Hydrological Implications of the 4000 MW coal-fired Ultra Mega Power Project in Cheyyur, Tamil Nadu

By Community Environmental Monitoring, a program of The Other Media
with inputs from S. Janakarajan, Siddharth Hande & Nityanand Jayaraman

July 2014

Figure 1: Map of Waterbodies and Stream Network in Project Study Area

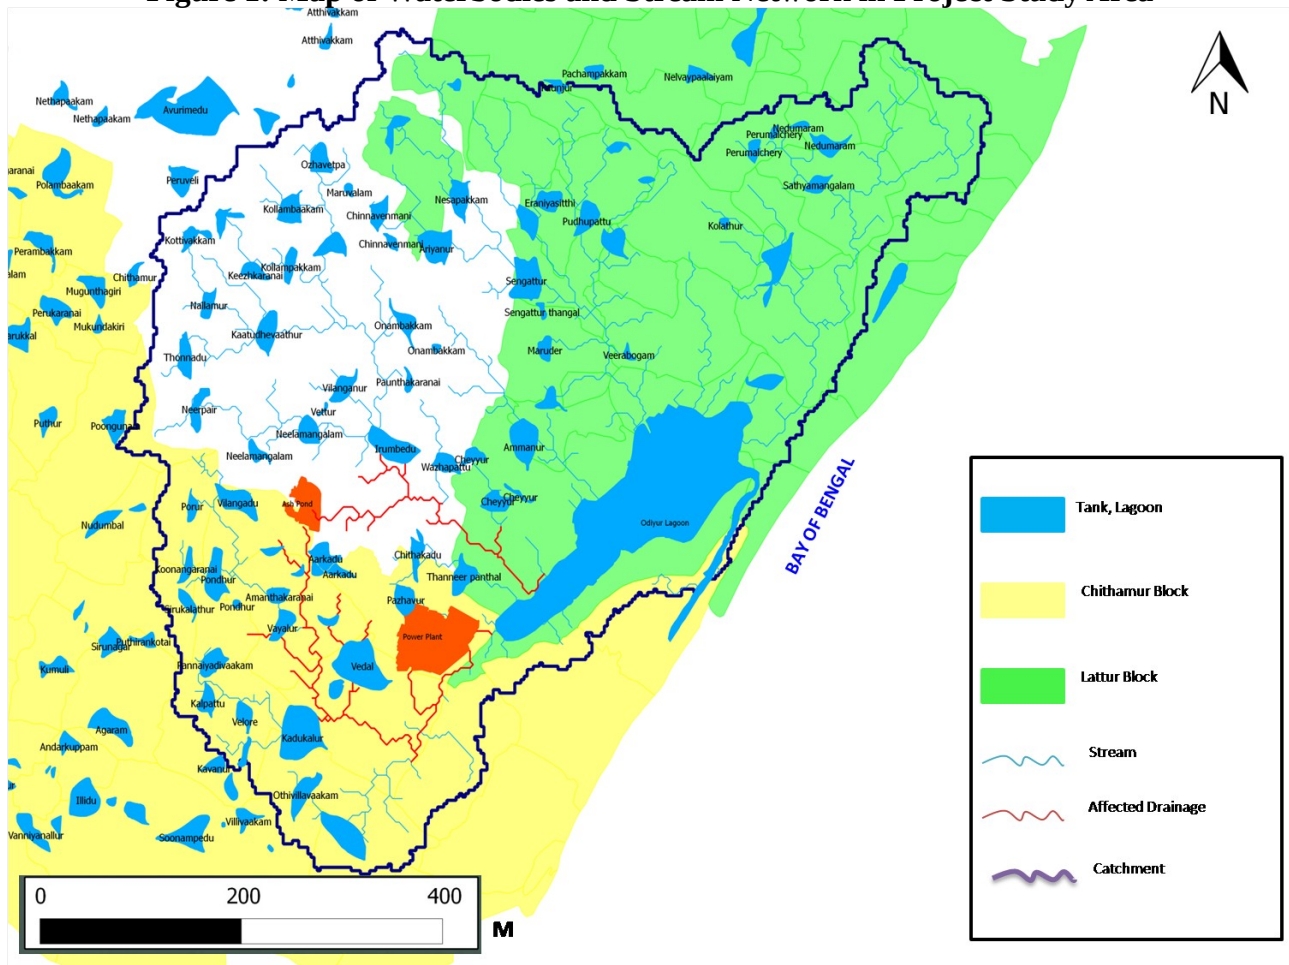
The ash pond lies upgradient of several irrigation tanks and the Cheyyur lagoon. The ash pond site slopes from 32 metres above mean seal level in the southwest to 22 metres in the northeast. The power plant site further southeast slopes from 14 metres above MSL in the south to 2 metres in the Northeast.¹¹ The area where the ash pond and power plant are located drain towards the Cheyyur lagoon through a network of streams. A visual depiction of the sub-basin containing the ash pond, power plant and stream network, including the streams likely to be impacted by the ash pond (shown in red), is in **Figure 1**.

The sub-basin containing the power plant, ash pond and captive port straddles three blocks – Maduranthakam, Chitamur and Lathur, and encompasses about 53 irrigation tanks. Rainwater falling within the sub-basin remains within this sub-basin, and drains to the sea through the Cheyyur/Odiyur lagoon and the river mouth south of Paramankeni through the Mudaliarkuppam estuary. **(See Figure1)**

The area's catchment depicted in Figure 1 was modelled using GRASS GIS' “r.watershed” module. This model delineates sub-basin watersheds and stream networks within it based on the contours and models water flows accurately. For the purposes of this study, the stream networks emanating from and influenced by the ash pond and power plant have been highlighted to indicate the sphere of influence through surface water flows.

Figure 2: Alignment of Coal Conveyor Corridor and Proposed Stormwater Drain

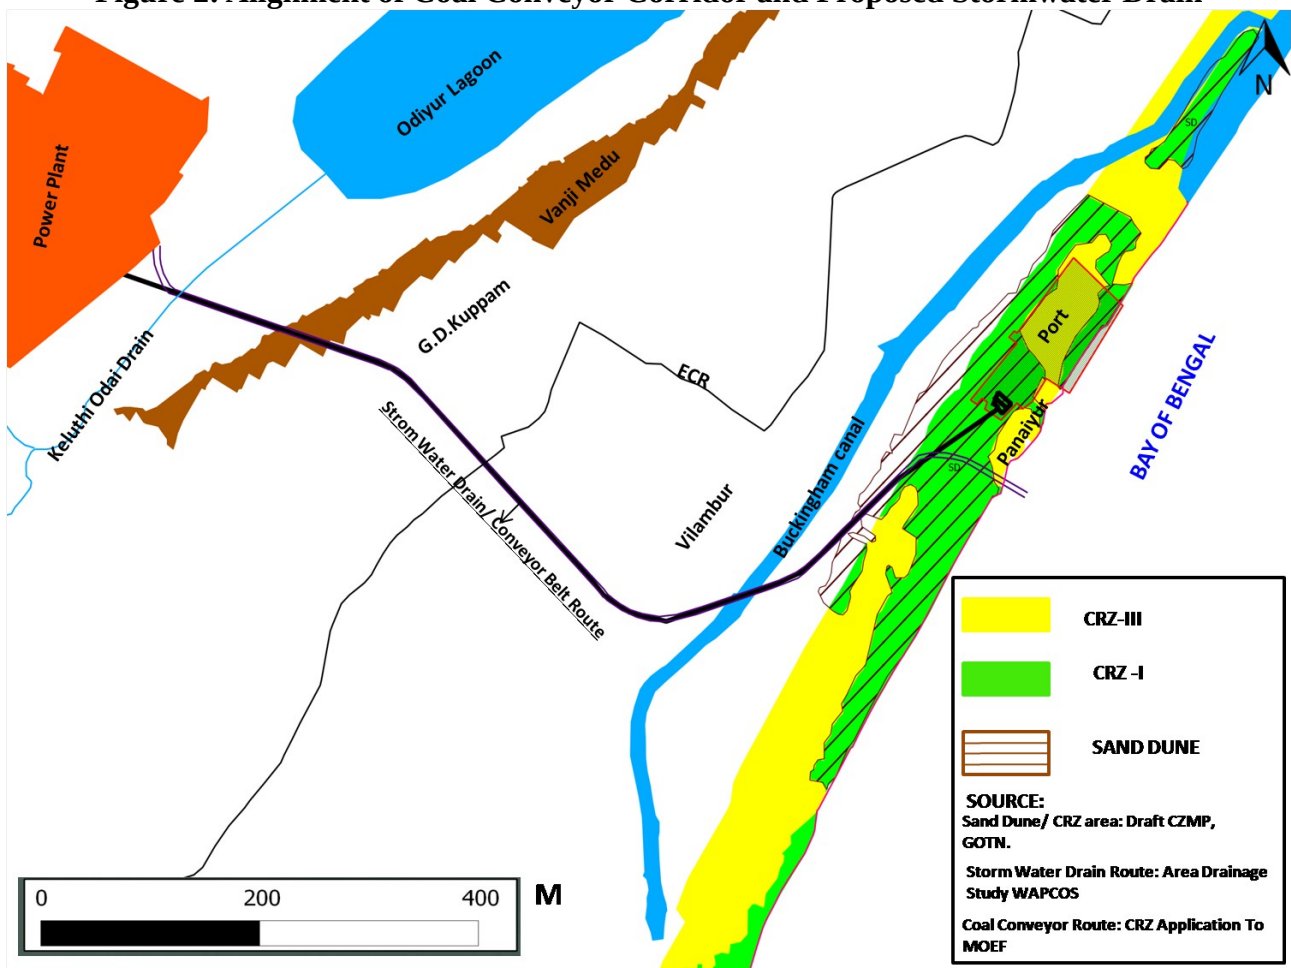
dunes, the Buckingham Canal, the East Coast Road, yet another ancient sand dune called the Vanjimodu and run across plains and a key drainage called Keluthi *odai* from the Vedal tank to the lagoon to reach the power plant. No contour details of this alignment have been provided as part of the project submissions. No drainage assessment seems to have been done for the coal conveyor alignment. (See Figure 2)

The stormwater drain proposed to be constructed to drain the rainwater falling on the plant site runs from the plant site along the alignment of the conveyor corridor until a point after the Buckingham Canal after which it turns due east and runs across formidable sand dunes to empty into the Bay of Bengal at a point just south of the boundary of Panaiyur Periakuppam. No drainage assessment seems to have been done for this component either.

Figure 3: Waterbodies within Acquired Plant/Ash Pond Sites

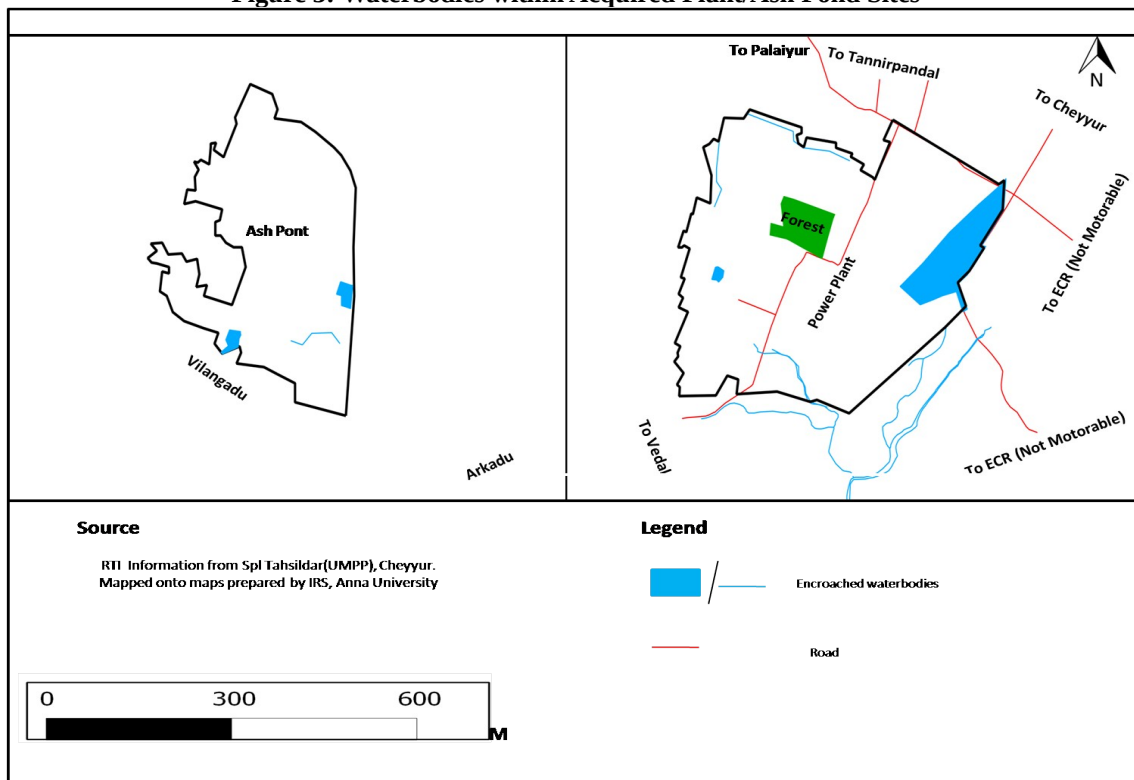
Revenue records obtained through Right to Information reveal that the power plant site encroaches on at least 150 acres of lands classified as waterbodies – including as backwaters, channels and streams.

Encroachment into the water spread areas and the catchment will have the long-term effect of dessicating the tanks and rendering them unfit for agricultural use or as reservoirs for water supply in the future. Given that such waterbodies also serve to recharge groundwater, the drying up of tanks is likely to make the area more vulnerable to salinity intrusion. It is to be noted that the Central Ground Water Board has found that two of the three blocks (Chitamur and Lathur) are already over-exploiting their groundwater reserves.
